17/04516/NONMAT (CD.2288/T)

**Land Adjacent To Harbourlow
Broadway Road
Mickleton
Chipping Campden
Gloucestershire
GL55 6PT**

Erection of a bungalow (Non-material amendment to permission 16/02322/FUL involving raising of ridgeline by 225mm, addition of 3 rooflights in north elevation and alterations to fenestration) at Land Adjacent To Harbourlow Broadway Road Mickleton Chipping Campden Gloucestershire GL55 6PT

Non-material amendment 17/04516/NONMAT	
Applicant:	Mr David Stowe
Agent:	Alscot Architecture Design & Planning
Case Officer:	Martin Perks
Ward Member(s):	Councillor Lynden Stowe Councillor Mark Annett
Committee Date:	13th December 2017
RECOMMENDATION:	PERMIT

This decision relates to drawing number P01 1617-35 Rev 15/11/17

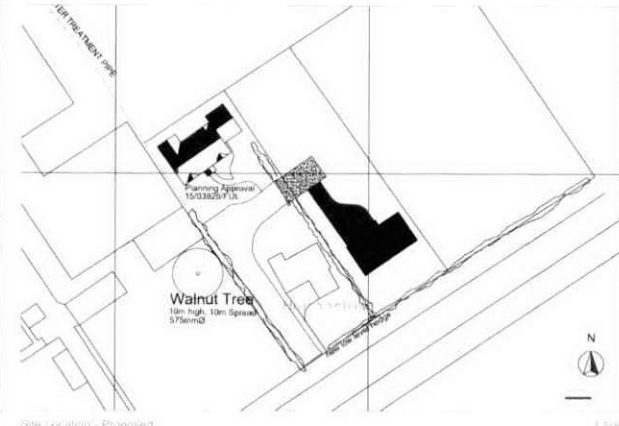
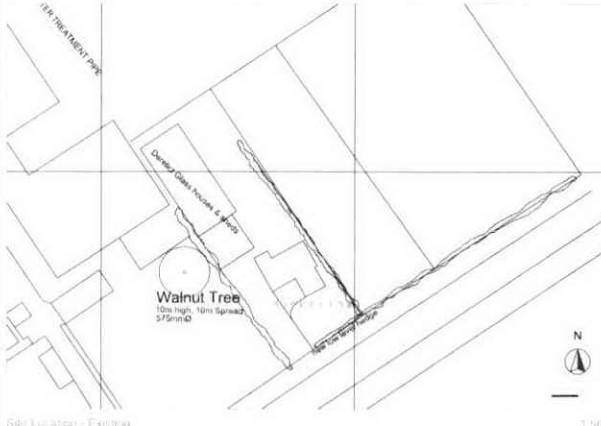
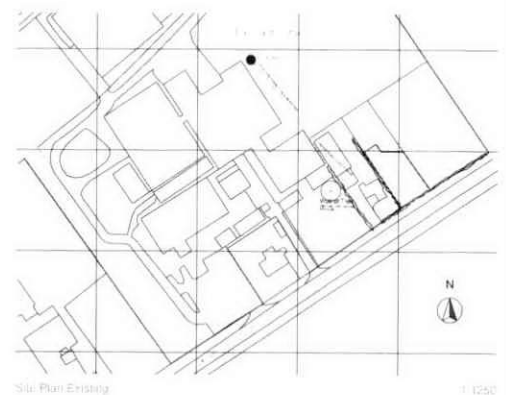
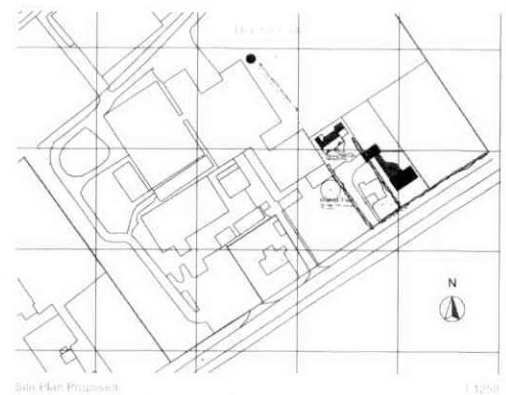
- i) raising the ridgeline of the approved dwelling by 225m to 6.225m.
- ii) inserting three rooflights in the northern roofslope of the approved dwelling.
- iii) the addition of a single light opening to the side of the front porch and the replacement of a three light casement window and door in the rear elevation with a two light casement window and glazed door.

The site lies in an area which is characterised by a variety of building styles and heights. There is no defining character in terms of design, size or scale. In the context of the site and its surroundings it is considered that the raising of the ridgeline by 225m will not have material impact on the design, proportions, size or scale of the approved dwelling.

The three rooflights will be positioned on the north facing roofslope and will therefore not be readily visible from the road. The rooflights could also be inserted under permitted development rights following the completion of the dwelling. The rooflights are also modest in size. It is considered that their insertion will not have a material impact on the approved scheme.

The additional window to the side of the porch is small in size and will mirror an approved window on the other side of the porch. It will provide more balance to the front of the dwelling. The changes to the rear elevation are not inconsistent with the arrangement of openings commonly seen in the garden elevation of dwellings. The elevation will face the road. However, it will be set behind a hedgerow and by virtue of the single storey nature of the development will not be readily visible from public view. It is considered that the changes will not have a material impact on the approved development.

It is recommended that the application is approved.
